**LEVY NUCLEAR PLANT, UNITS 1 AND 2  
DOCKET NOS. 52-029 AND 52-030  
RESPONSE TO REQUEST FOR ADDITIONAL INFORMATION LETTER NO. 070 RELATED TO  
BASIC GEOLOGIC AND SEISMIC INFORMATION**

**Levy Nuclear Plant Units 1 and 2**  
**Response to NRC Request for Additional Information Letter No. 070 Related to**  
**SRP Section 2.5.1 for the Combined License Application, dated November 2, 2009**

**NRC Letter No.:** LNP-RAI-LTR-070

RAI 02.05.01-47 Figure 1  
 Figure 2-14 from MFL Technical Report  
 (Reference RAI 02.05.01-47 02)

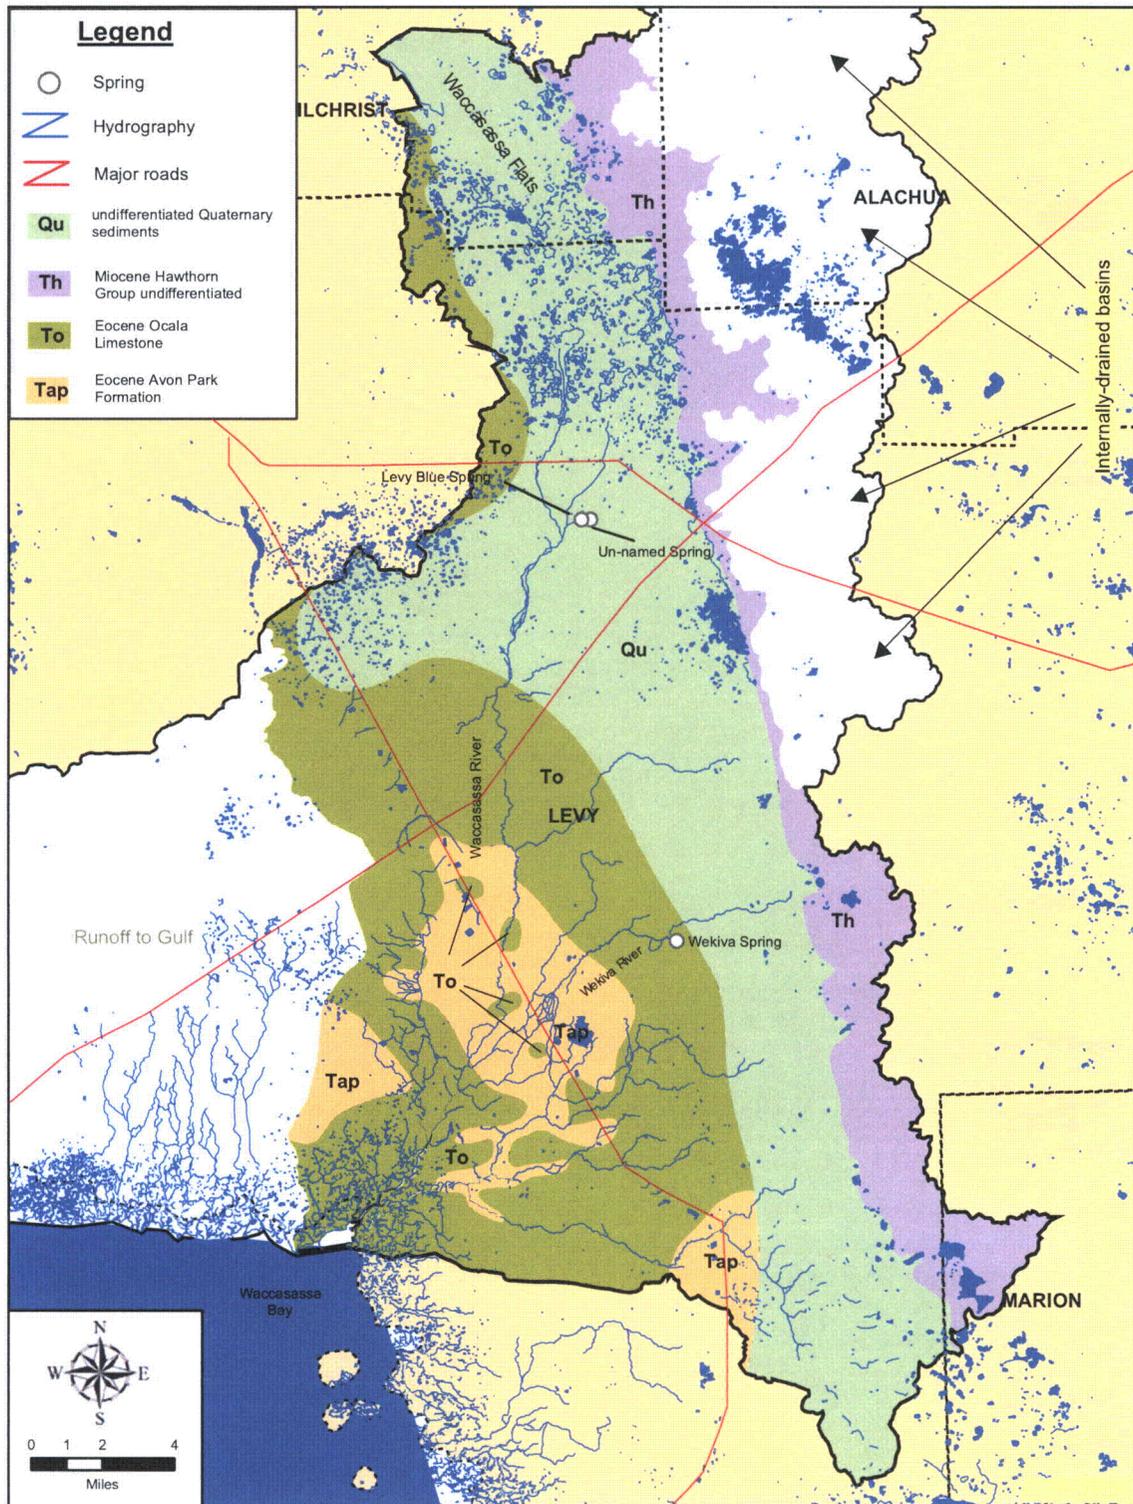
In order for the staff to assess the basis for the conclusion drawn by Upchurch which is stated in the response to RAI 2.5.1-31 regarding the point that no springs of any noticeable magnitude occur with the LNP site vicinity, please cite an appropriate reference documenting his conclusion that no springs exist.

Springs in the Levy County vicinity are discussed in Scott et al. (2004) (Reference RAI 02.05.01-47 03), which presents the results of research conducted by the Florida Geological Survey (FGS) Springs Teams. These teams found two small (third magnitude) springs, Big King Spring and Little King Spring, near the LNP site. These springs are believed to be the result of similar permeability differences as discussed by Upchurch. Big King Spring, Little King Spring and Wekiva Spring are the nearest named springs to the site as shown in RAI Figure 02.05.01-47 Figure 2 (Revised Figure 2.5.1-244 with annotations as shown in Attachment 02.05.01-47C).

- The springs are limited to the edge of the outcrop belt of the Ocala Limestone. We know of no significant springs within the Avon Park Formation (there are probably some seep springs on bedding planes, but none are of sufficient magnitude to attract attention). I believe that the Levy County springs are within the Ocala Limestone where flow is forced to the surface because of the permeability contrast with the significantly less permeable Avon Park. If you refer to Figure 2-14 in the publication referenced above, Wekiva and Levy Blue Springs fall at the Ocala/Avon
